**From:** Kim Burgess  
**Sent:** 29/08/2023 3:31:29 PM  
**To:** Council Northernbeaches Mailbox  
**Subject:** TRIMMED: DA2023/0976 - 20-22 MACPHERSON STREET,  
WARRIEWOOD  
**Attachments:** Submission against Development 20-22 Macpherson St.pdf;

**RE: DA2023/0976 PROPOSED SUBDIVISION INTO 53 LOTS AND  
THE CONSTRUCTION OF 53 DWELLINGS  
20-22 MACPHERSON STREET, WARRIEWOOD**

#### Terrestrial Biodiversity Map – Environmentally Sensitive Land

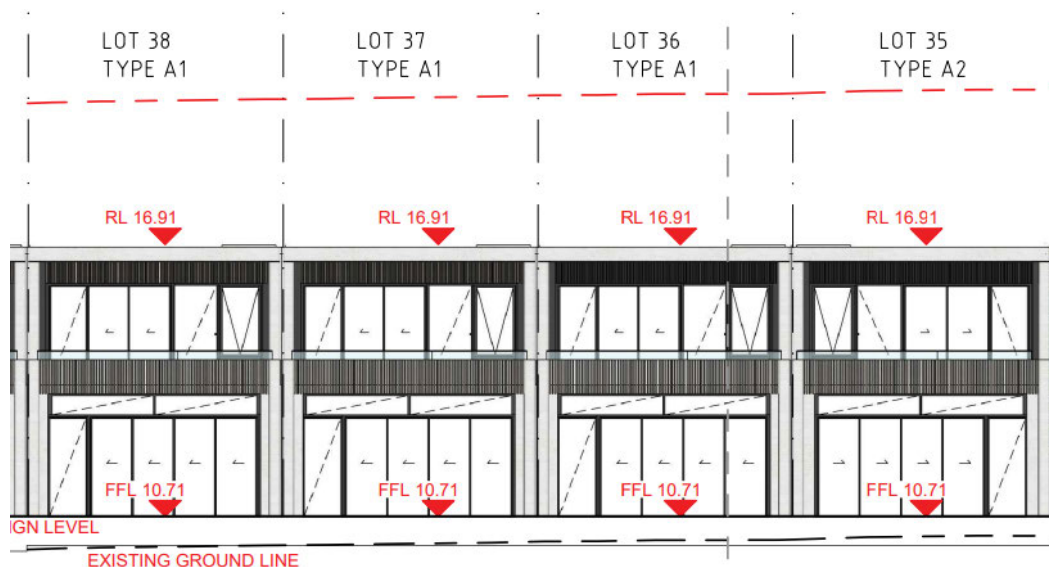
- **Biodiversity and landscaping:** The site is in the R3 Medium Density Residential Zone and adjoins the RE1 Public Recreation Zone. The Terrestrial Biodiversity Map affects approximately one third of the subject land which is classified as an Environmentally Sensitive Area as shown in the figure below. While the development has attempted to recognise this area and has provided some planting, the proposal is still inadequate. The developer has included the rear and/or front yards of Units 18-29 and Units 36 and 37 and Driveway 2 within the Environmentally Sensitive Area where the area should be left free of development.

Further, only 16% of the remainder of the site will be shaded by tree canopy where the figure should be 40% in accordance with the private open space areas. The proposed landscaping within the lots is not adequate to achieve mature vegetation, particularly the units with a wooden rear deck.
